Service Bulletin #204

SUBJECT: Lower Shift Rod Freeze-Up on Snowthrowers

Units Involved: All 5, 8 & 10 HP 5-Speed Snowthrowers produced prior to the 1984-85 season incorporating the sliding shift rod design (Fig. 1 & 2) identified also by S.N.'s lower than 3313C1001 and Date Code 3L12C11 for Ford Units.

FIG. 1

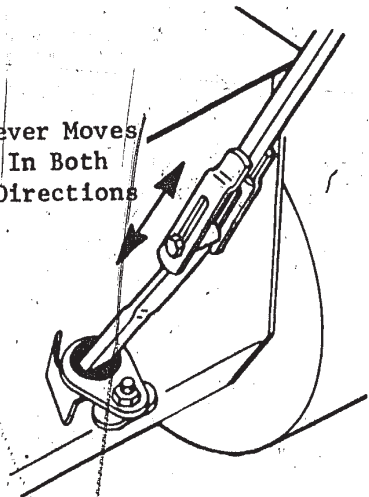
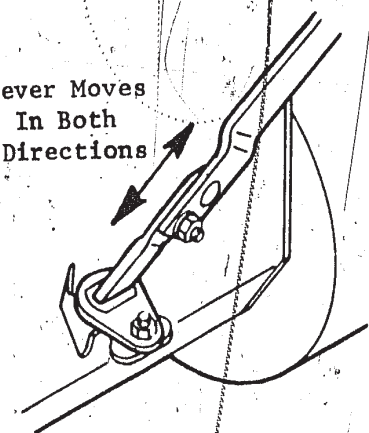
We have received reports from the field advising that the lower shift rod freezes or hangs up in the bottom bushing and shifter bellcrank through which it passes. On the subject units, minimal frictional contact in these areas is beneficial for ease of operation.

We are making available new lower shift rods for the subject units which contain milled slots on all four sides. Should a problem be encountered in which the problem described occurs, the following interchange list will assist you in obtaining the correct new style lever that may be installed:

<u>Orig. Lever</u>	<u>Length</u>	<u>Replacement Lever</u>
209359	8-3/4"	88098
218926	9-3/8"	88099
218934	14-1/16"	88100
